ATTACHMENT

SAMPLE QUESTION
AB-028

TYPICAL PLAN @
UPPER FLOORS

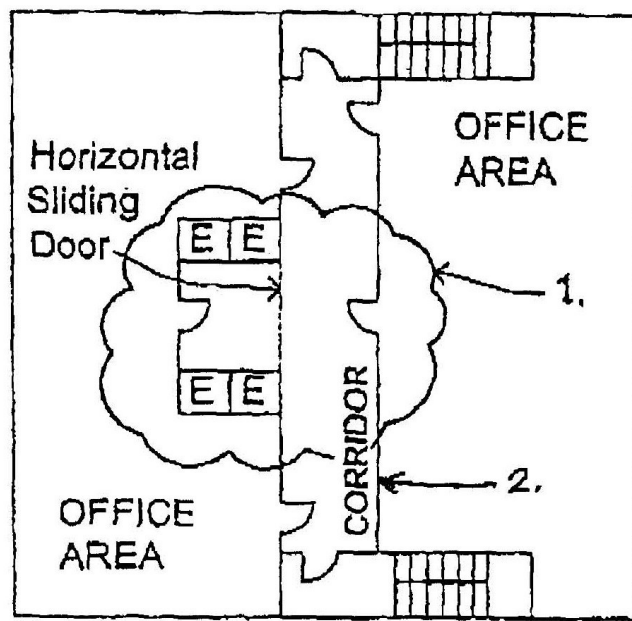
1. Regarding the typical 56 foot square floor plan of a four-story, fully sprinklered office building as shown, would the elevator lobby be permitted to open onto the corridor? The floor is occupied by a single tenant of less than 30 occupants. The elevator hoist way and stair enclosures are not pressurized. (San Francisco Building Code Section 708.14.1

2. Is a fire-resistance rated corridor required to connect both exit enclosures? (San Francisco Building Code Section 1015, Section 1016, and Section 1018.)
